APPROVED
DRAINAGE PLAN

SKETCH PLAT
STARKEY DEVELOPMENT CENTER

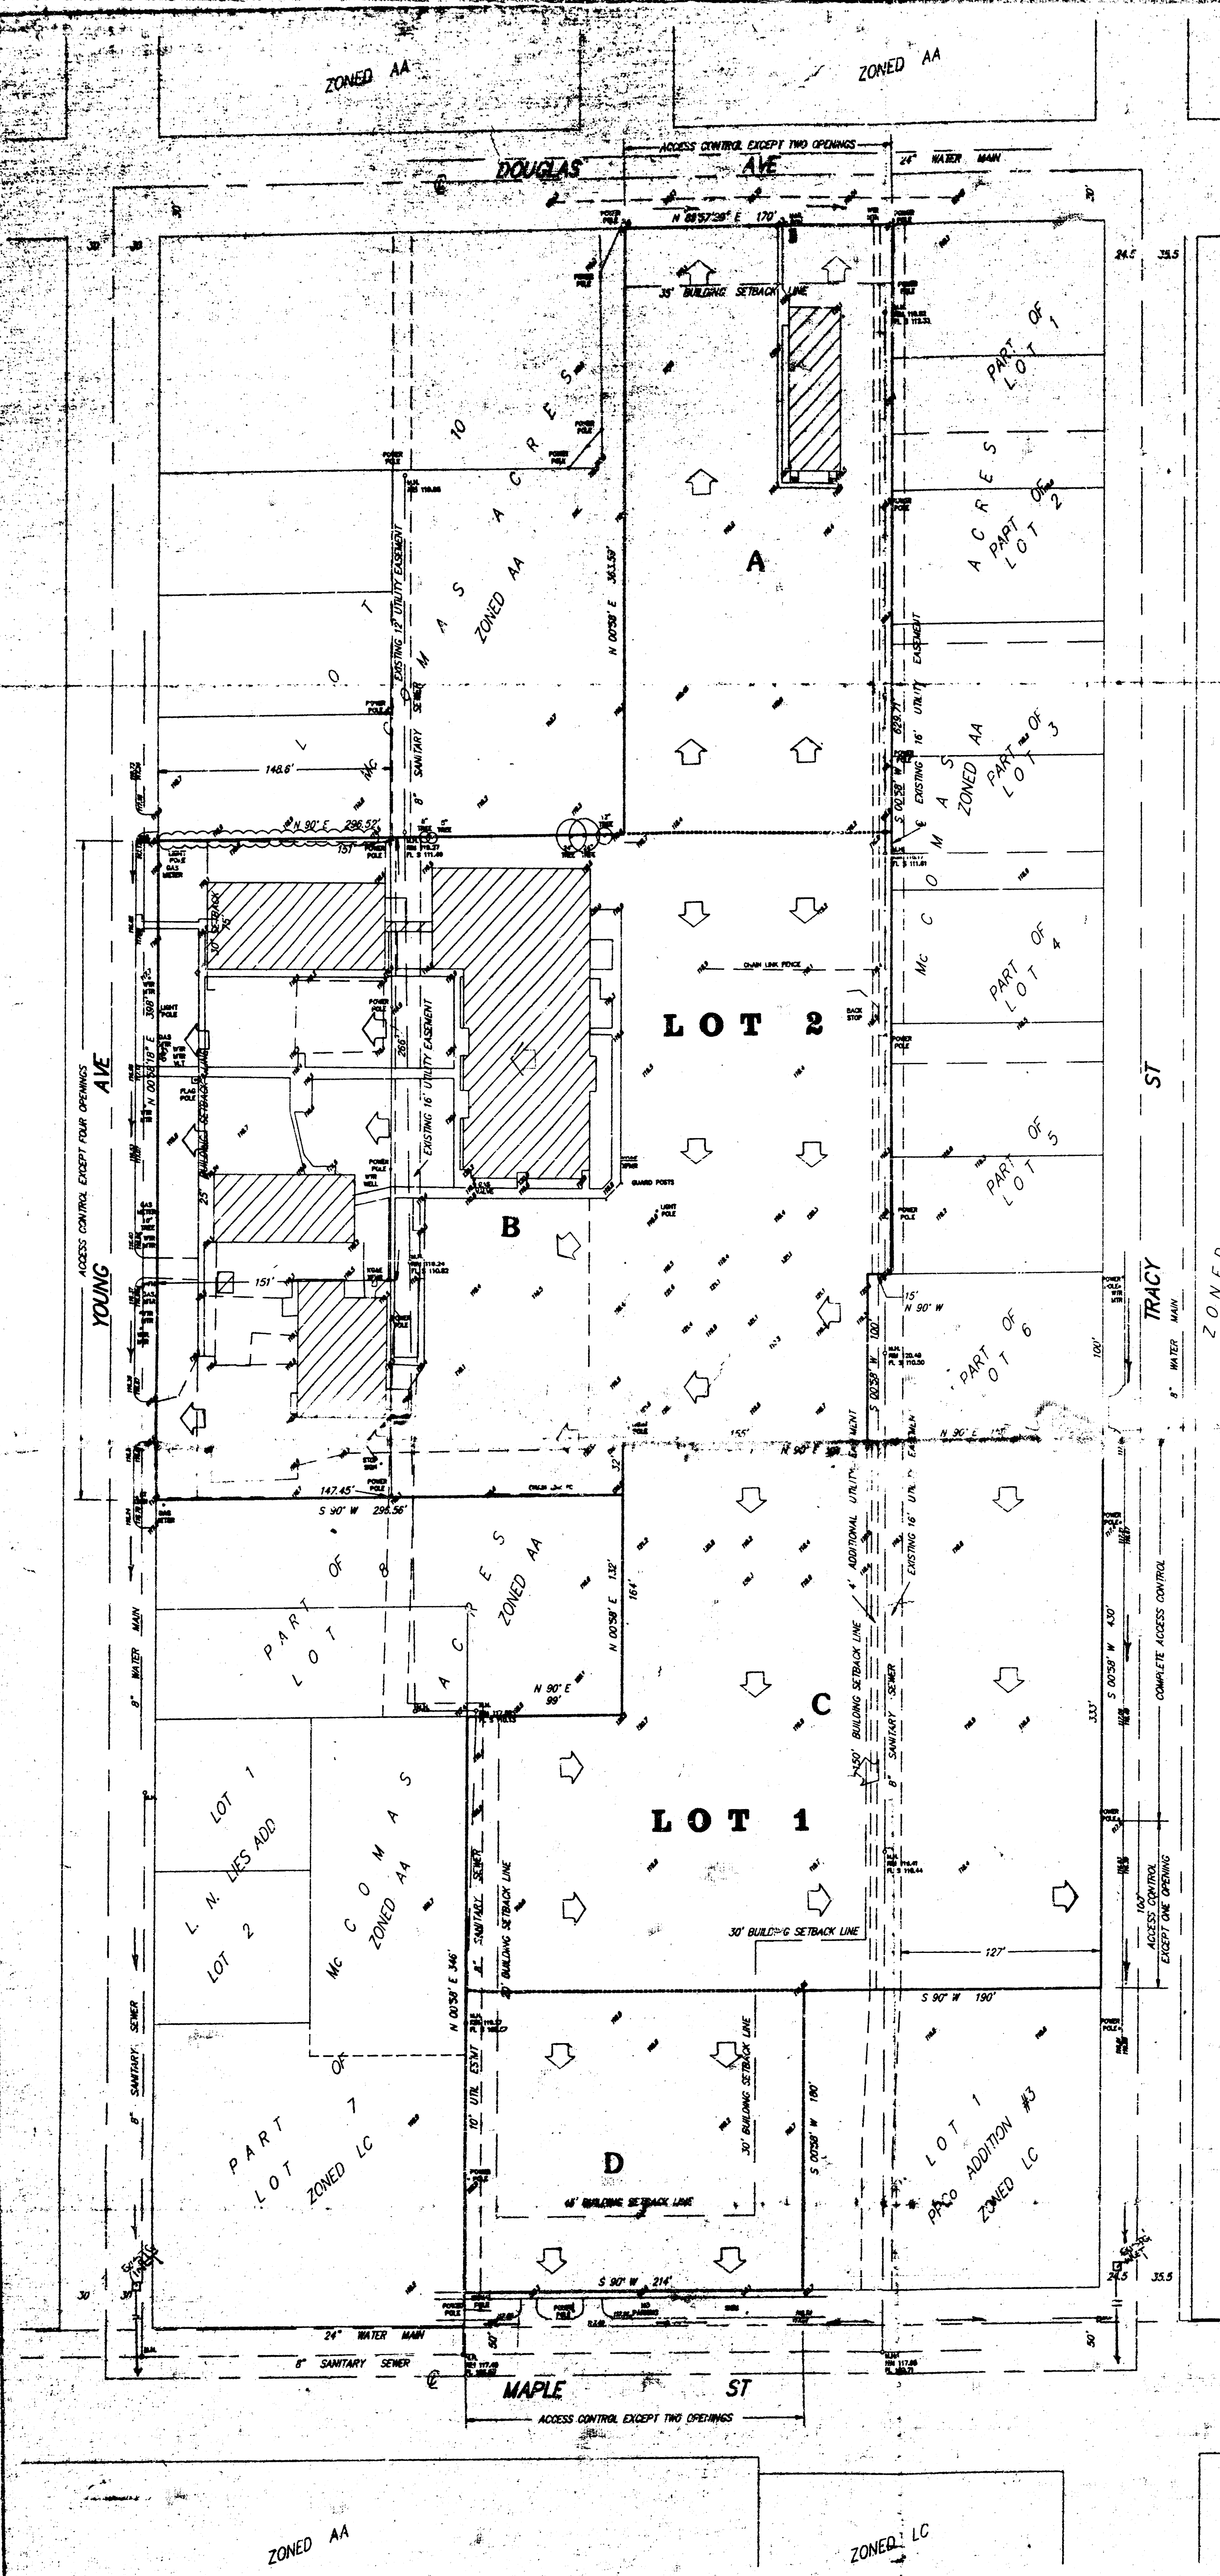
Area C shall be limited to the existing condition discharge runoff amount draining to Tracy St. The amount of allowable runoff to Tracy from Area C shall be 5 C.F.S. which is the 100 year storm discharge with a runoff factor of 0.25.

An alternative to the detaining runoff method is to extend storm sewer from Maple into the Area C side.
